ALERT SERVICE BULLETIN

NO. 412-01-107

SUBJECT: MAGNETIC BRAKE P/N 204-001-376-003, ONE TIME INSPECTION OF.

HELICOPTERS AFFECTED: Model 412 & 412EP helicopters and all delivered spare Magnetic Brakes P/N 204-001-376-003.

FIGURE 1

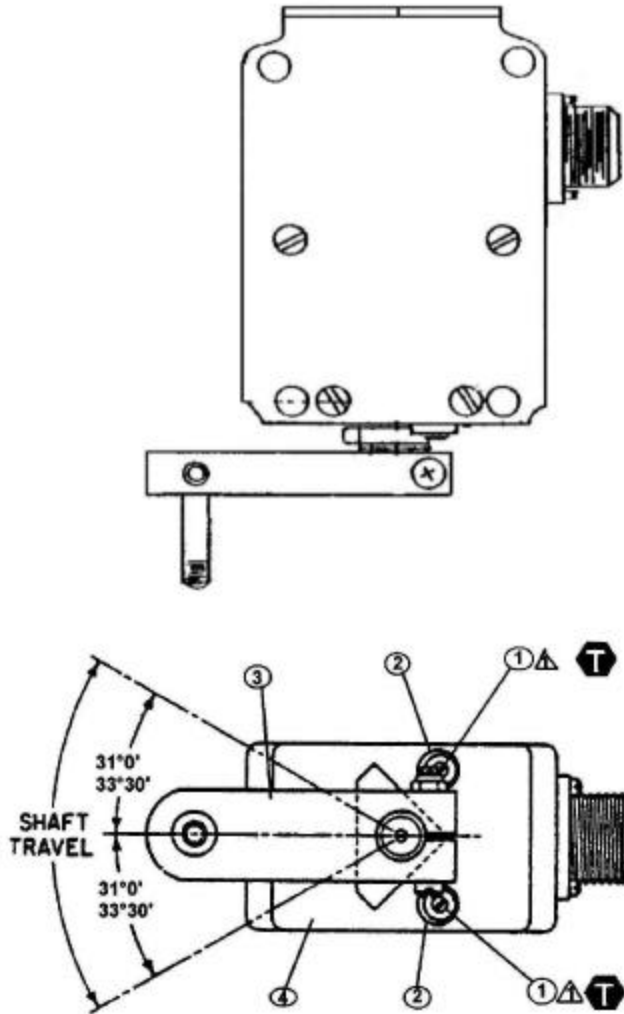
4. Using a mirror and a flashlight, inspect the Magnetic Brake installed to determine if it is manufactured by Memcor Truohm, Inc. by identifying P/N MP498-3. If the Magnetic Brake is P/N MP498-3, continue with step five (5) of this Alert Service Bulletin. If the Magnetic Brake is not manufactured by Memcor Truohm, Inc. proceed to step 12 of this Alert Service Bulletin.
5. Using a suitable torque wrench and screw driver bit apply 10 inch/lbs(1.12 Nm) force to screw(s) (1 figure 1) in a counterclockwise direction. If screw(s) (1) does not move, proceed to step 11. If any movement is found on screw(s) (1) proceed to the following steps.

If the inspection reveals that screw(s) (1) has disengaged, inspect arm assembly (4) for mechanical damage created by screw(s) (1). If mechanical damage is found, the depth shall not exceed 0.030 inch (0.762 mm). Acceptable damage may be smoothed and treated in accordance with the Standard Practice Manual Chapter 3 for Chemical Film. If damage is greater than 0.030 inch (0.762 mm) contact Product Support Engineering.

6. Remove screw(s) (1) and stop limit(s) (2) from magnetic brake (4).

7. Clean dried adhesive from magnetic brake (4) screw holes and screw(s) (1) with compressed air.
8. Apply adhesive (C-320) to screw(s) (1) threads and install in magnetic brake (4) hand tight.
9. Adjust the stop limit(s) (3) to achieve the arm assembly shaft travel as per dimension in figure 1.
10. Once shaft travel is obtained, torque screw(s) (1) 5 to 10 in-lbs (0.56 to 1.12 mm).
11. Apply torque seal inspection ink to screws (1) and to the stop limits (2).
12. Re-install anti-torque magnetic brake access panel.
13. Connect battery.
14. Make an entry in the helicopter historical records indicating compliance with this Alert Service Bulletin.

- Bond screw with adhesive C-320
- 5 to 10 IN-LBS
(0.56 TO 1.12 Nm)
